Proposal for draft amendments to Regulation No. 58 (Rear underrun protection)

The text below is a proposal from OICA to provide an alternative to the proposal from Germany per document ECE/TRANS/WP.29/GRSG/2013/27. It does not change the OICA position expressed at previous 105th session of GRSG questioning the relevancy of the principle of making changes to the regulation before the outcomes of the 02 series of amendments are assessed.

Justification paragraph 7.4.2. and paragraph 25.8.2.

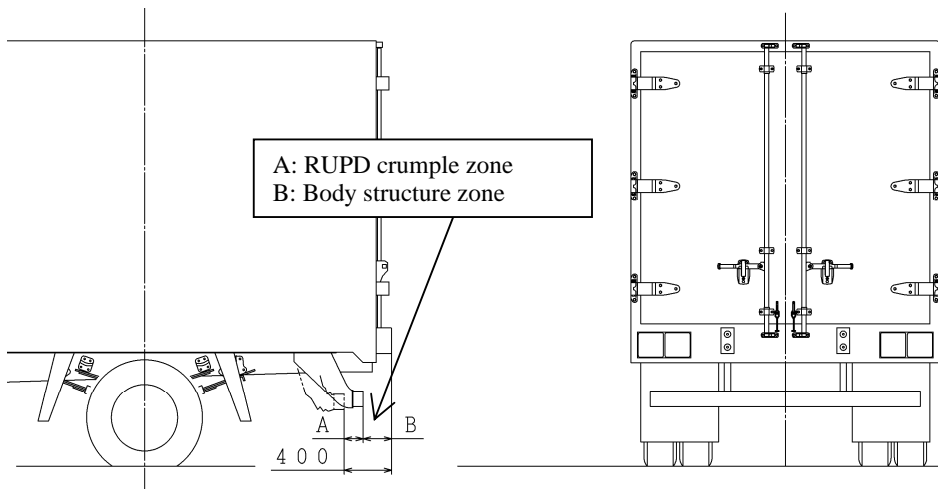
The increase of the height of the RUPD for vehicles of category O3 and O4 from 100 mm up to 120 mm results in some design restrictions for the individual elements of the underrun protection in combination with a lift mechanism. The separate outboard elements of the RUPD may not meet the required effective surface of 420 cm² due to the effective height over ground of the RUPD, the design of the platform lift mechanism, the effective surface of rear lamps and the geometry of the longitudinal main beams of the trailers. In this case the manufacturer shall demonstrate this impossibility to the type approval authority or technical service.

- "7.4.2. The individual elements of the underrun protection, including those outboard of the lift mechanism, where provided, must have an effective surface area **in line with the values in Annex 6 of this Regulation**, ~~in each case, of at least 350 cm².~~

The effective surface area may be reduced when it is impossible to meet the values. In this case the manufacturer shall demonstrate this impossibility to the [type approval authority / technical service].

GRSG-104-49 (FIA-page 6 -bottom right figure). Rubber on the right hand side is delaminated, crushed by the passenger car impact.

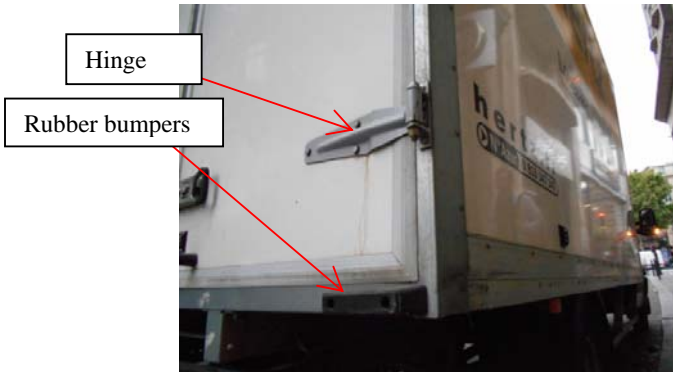
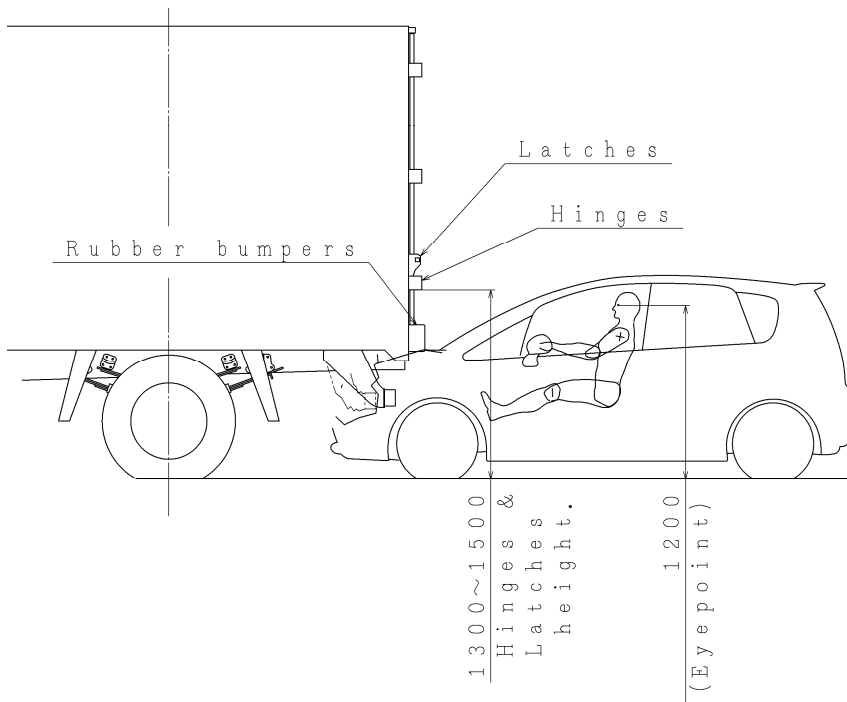
Tail lights, [rubber bumpers/resilient buffers], hinges and latches which are projecting over the rear end have very little influence in a rear end collision, thus they should be excluded from the rearward points of vehicle.

Considering the highest level of safety to passenger cars occupants, RUPD manufacturers give preference to a large deformation in order to achieve best energy absorption. However, if non-structural protrusions were included in the calculation of the rearward points of the vehicle, the deformation amount of RUPD would logically be limited since they also need certain space for structure deformation.

Concerning tail lamps and rubbers, they are not as strong as the passenger cars structure and will be detached by a rear end collision:

GRSG-104-49 (FIA-page 6 – 2nd top figure). Hinges and latches are located higher than the starting point of under-run, thus the risk of injury due to hinges an to the passenger cars' drivers and/or passengers is low.

- (a) any part of the vehicle which is more than 2 m above the ground when the vehicle is unladen shall be excluded;
- (b) **nonstructural protrusions such as tail lights, [rubber bumpers/resilient buffers], hinges and latches shall be excluded from the determination of the rear extremity.**"
